Letter of Objection to the development at Former Tower
Car Sales, Tower Close, East Grinstead, West Sussex
(now known as Whittaker House, 1 Leppard Walk) and
retrospective application DM/26/1449

This application is ostensibly the same as the original application DM/26/0432; due to this I have included my original complaint letter from that application as Appendix A to this letter – I would like my original letter of complaint for DM/20/0432 to be considered in its entirety regarding this application.

Appendix A – original letter of objection for **DM/26/0432**

Letter of Objection to the development at Former Tower
Car Sales, Tower Close, East Grinstead, West Sussex
(now known as Whittaker House, 1 Leppard Walk) and
retrospective application DM/26/0432

The opaque glass is now our back door and access to the bin and bike stores, with the electrical cupboard in place of the hallway to a dedicated entrance

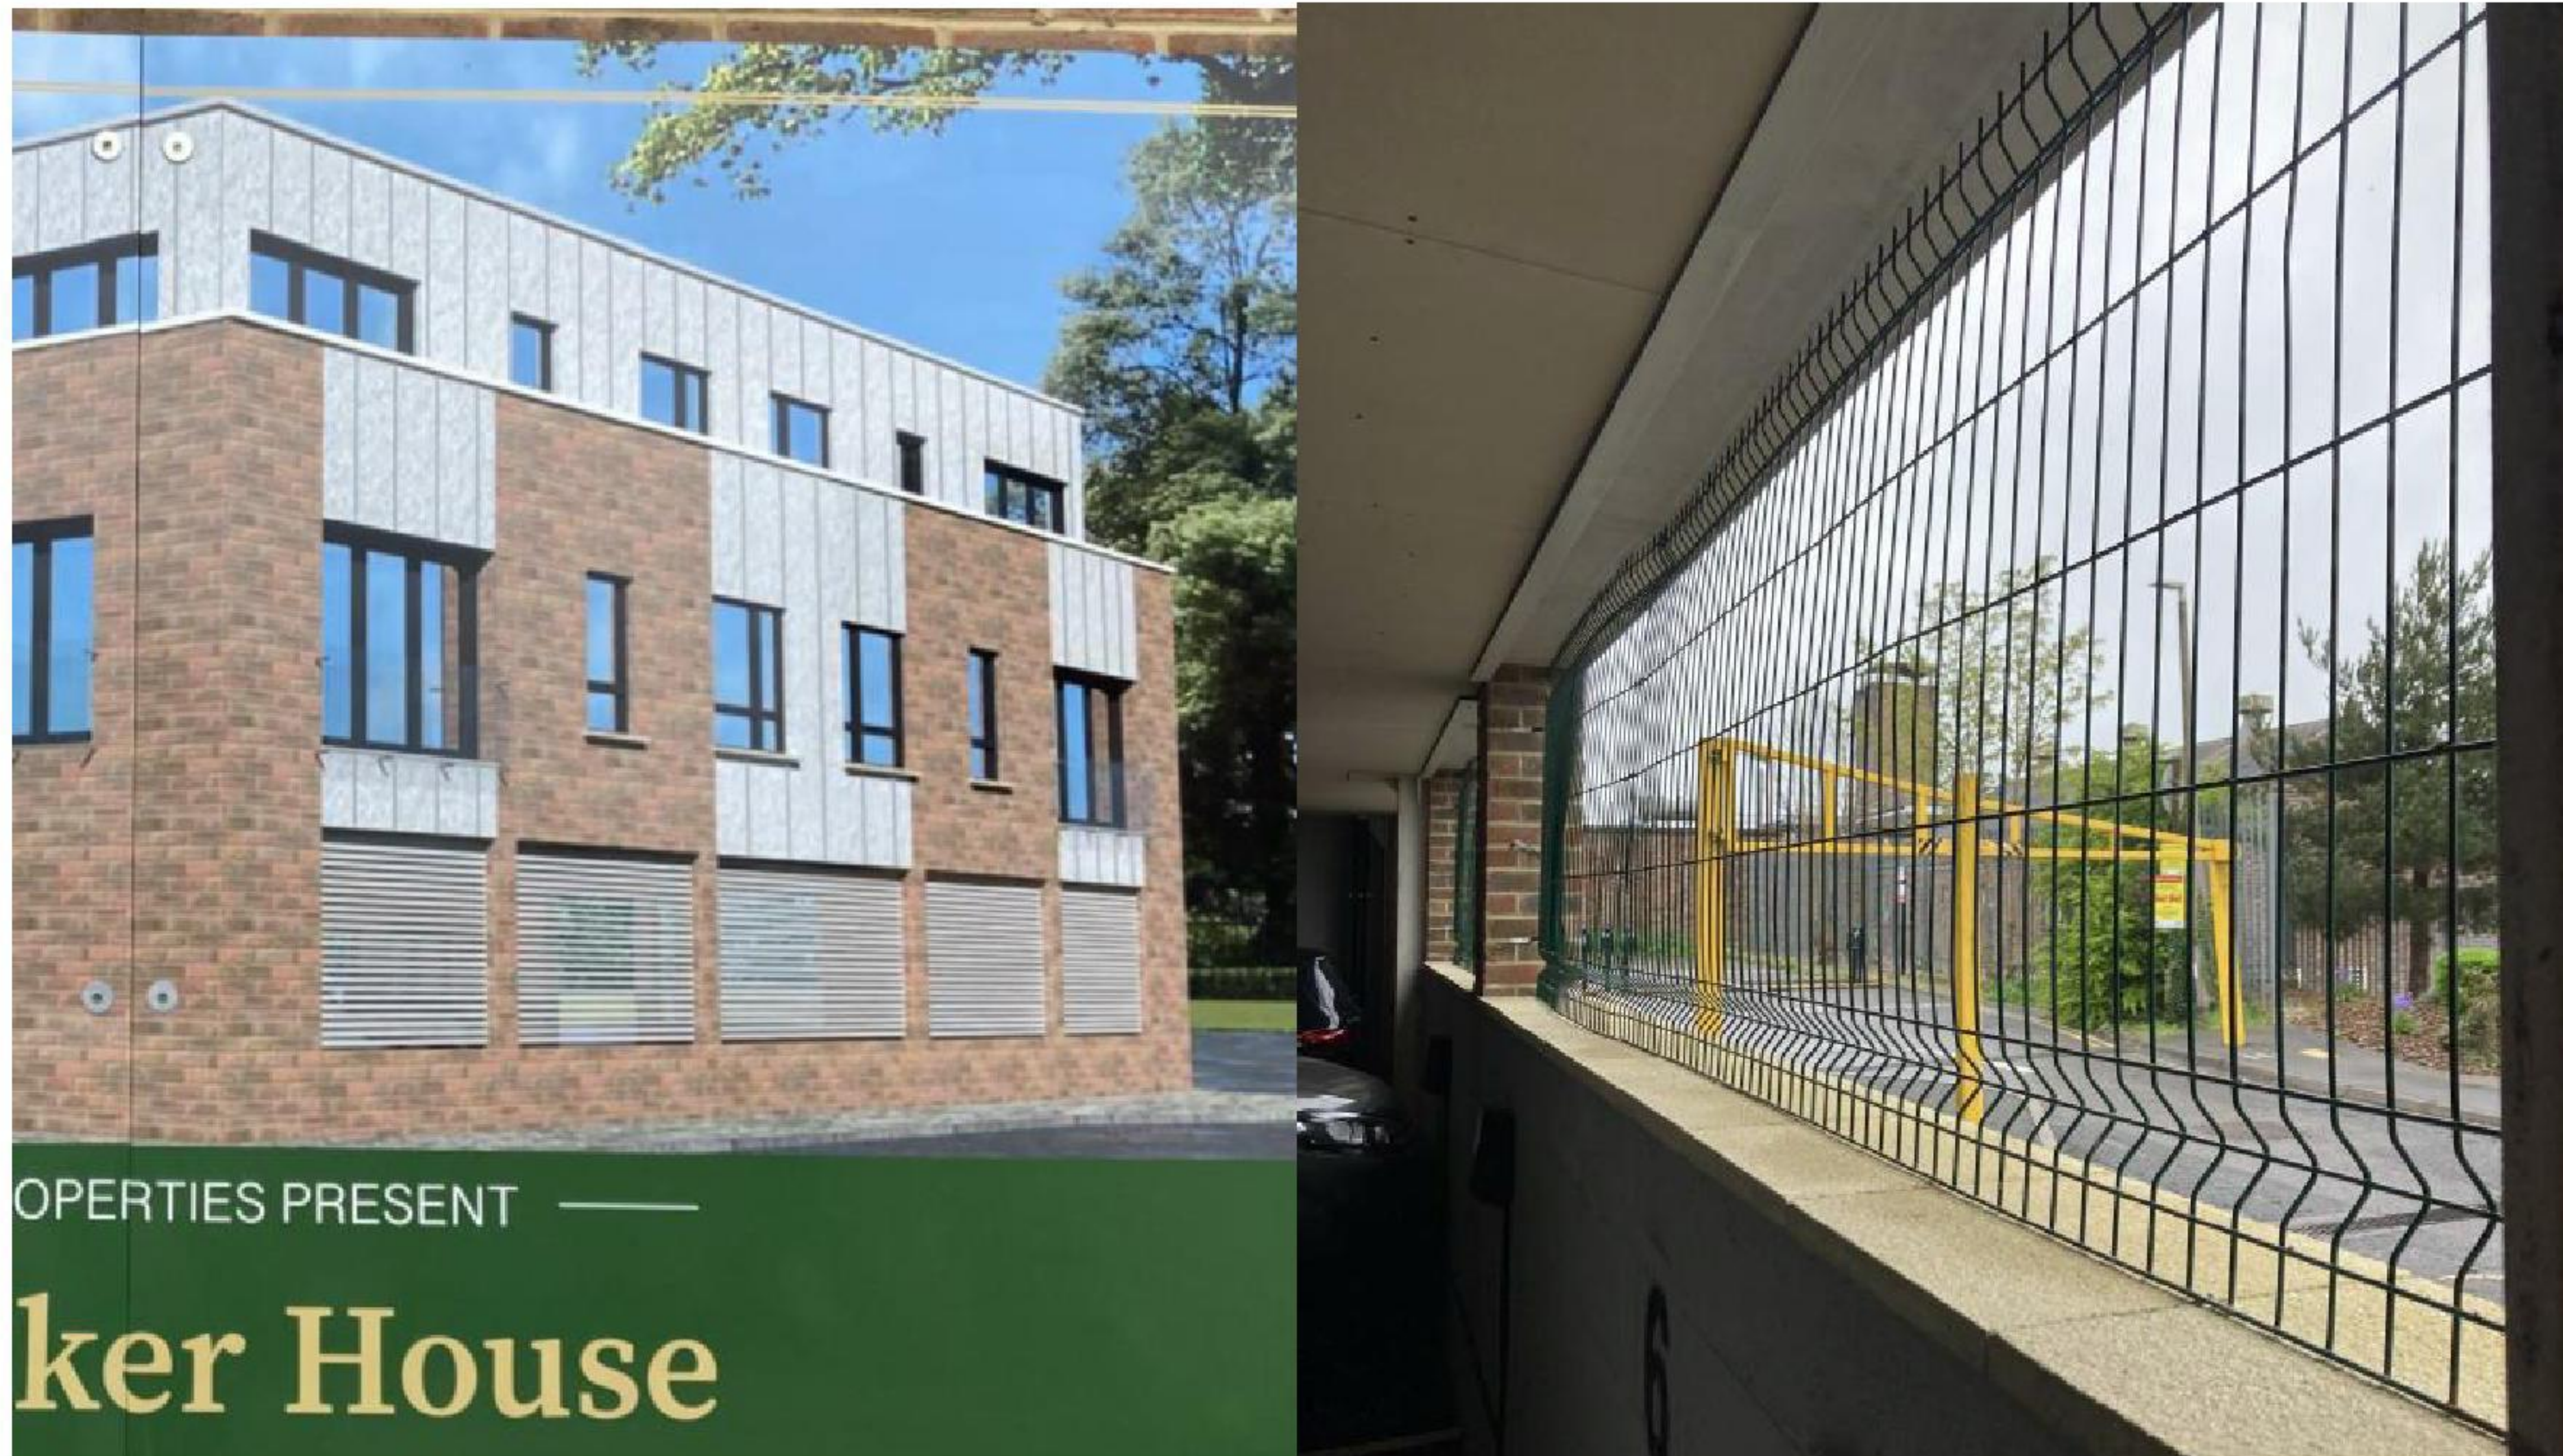
Planning permission for Whittaker House was granted on the expectation that residents would not need to enter through the undercroft, and they would have a dedicated entrance. This has also been sacrificed to make room for a potential 10th flat, with the entrance now located within the undercroft. None of the entry systems, neither internal nor external, have ever worked. The developer has been reached out to numerous times to correct this, but as of writing, no one in Whittaker House is able to receive guests, or secure deliveries, without either getting telephoned first or waiting outside the property. This is yet again more proof of the developers lack of character, and the disparity between what both we and the Planning Office were sold versus what was delivered.

The opaque glass has now been replaced with a back door, which accesses the bin and bike storage and takes us past Flat 1A's front door. The area under the stairs, which was supposed to be our hallway through to a front door, is now the cupboard where all our meters are stored. Further proof that the developer had no intention of building to plan, permission, or sales materials:

The sales poster for Whittaker House (also submitted in plans); The current car park grills

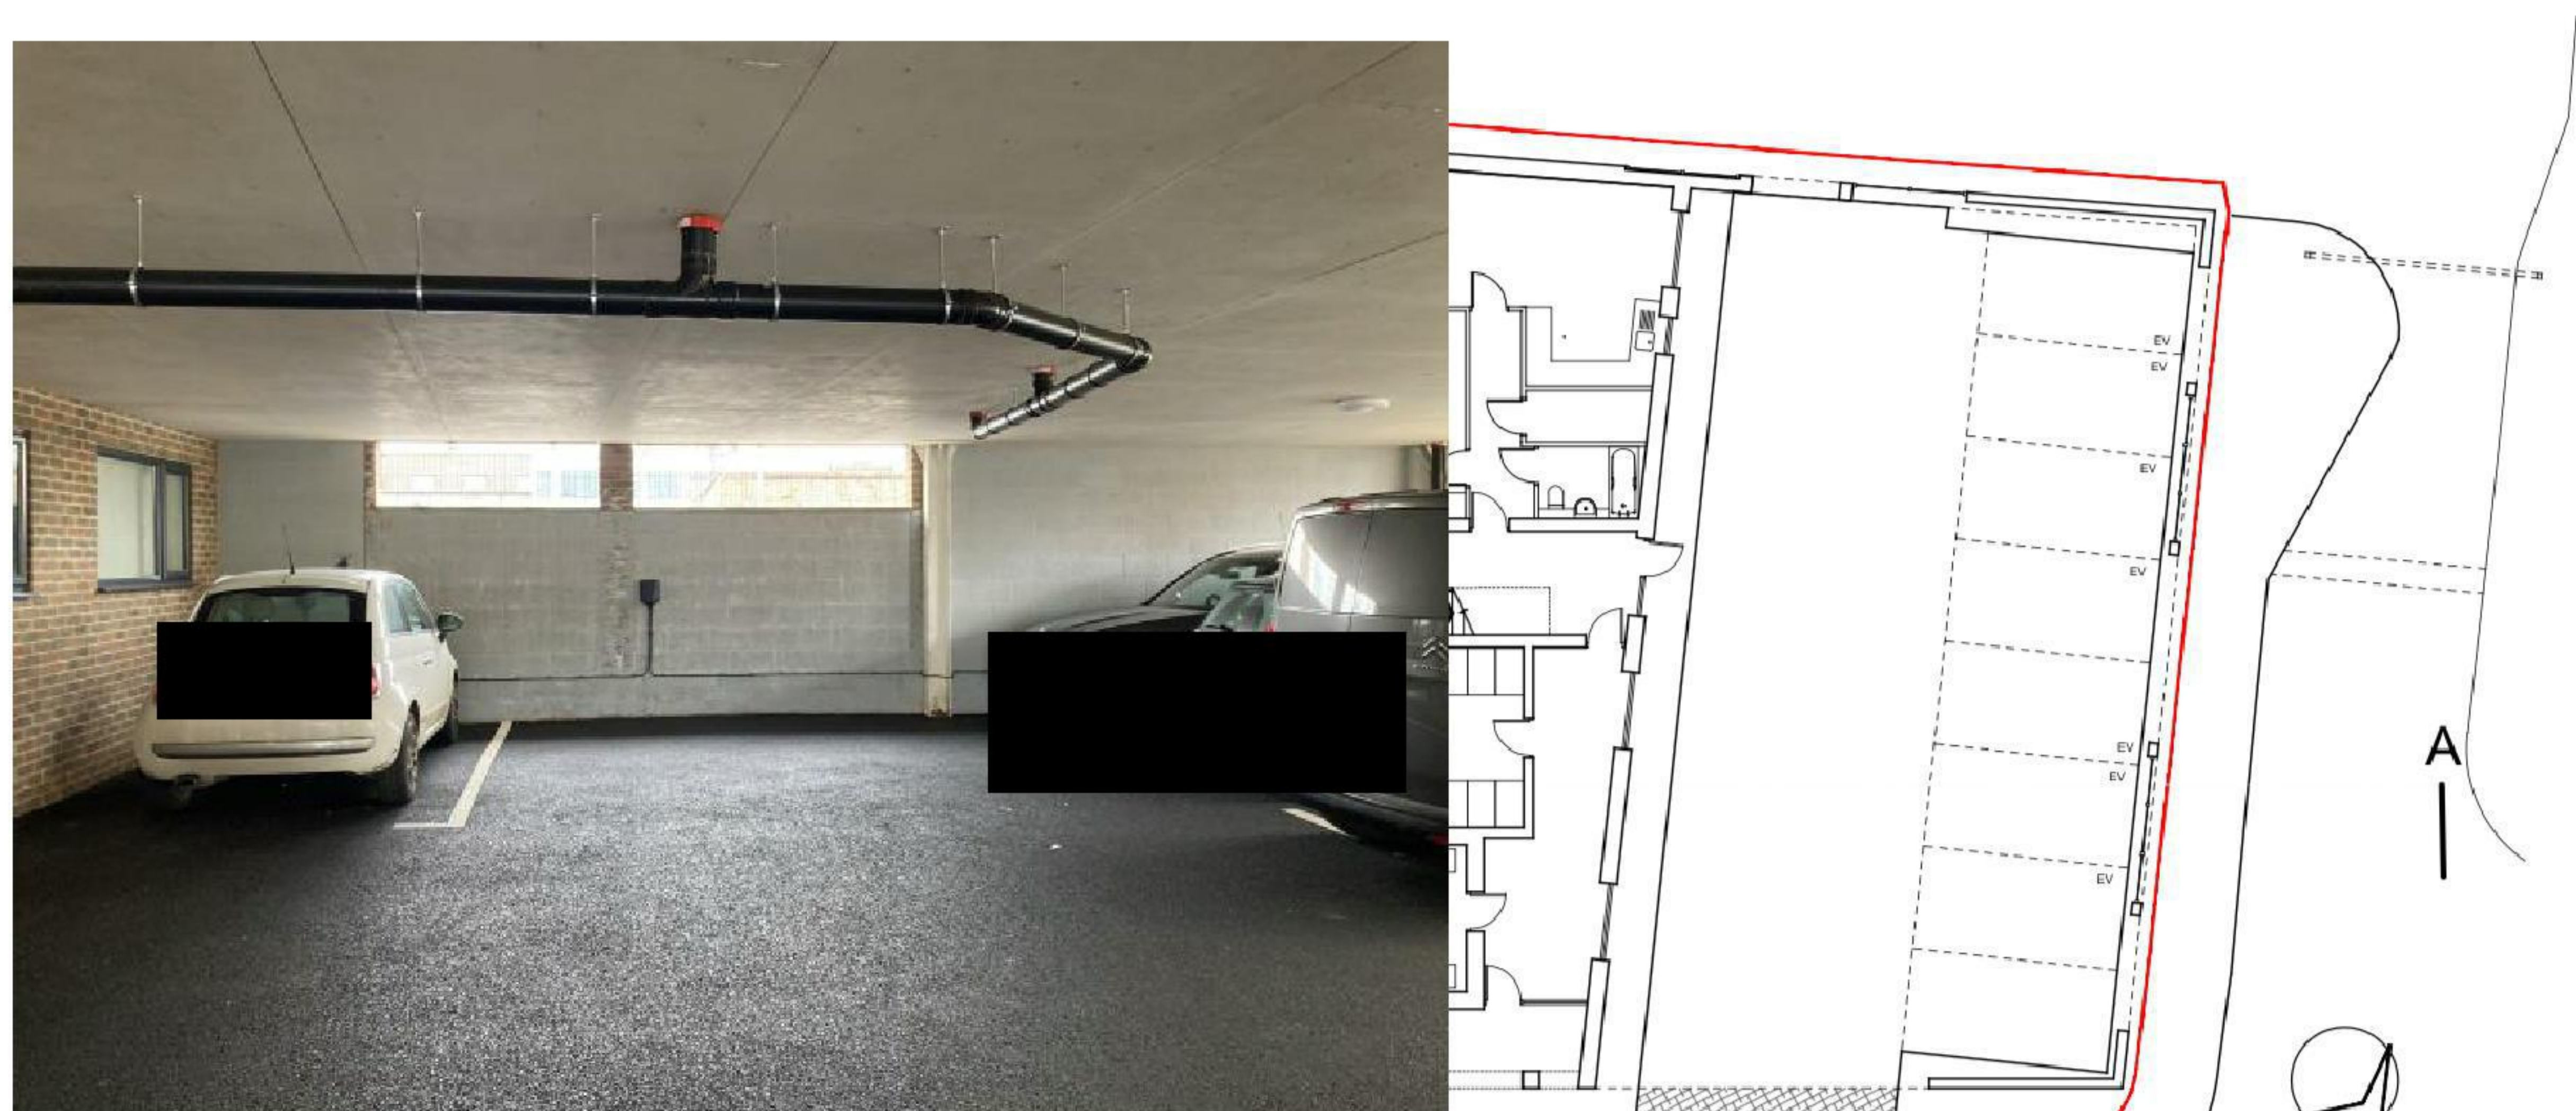
This was originally designated for 8 parking spaces, with tasteful exterior slats (or filigreed metal screens, depending on the submitted pictures). What we have been given more closely represents a snipers nest in Fallujah. This has a considerable effect on the exterior appearance of the building, and combined with the new front facing refuse area, significantly lowers the appearance of the neighbourhood:
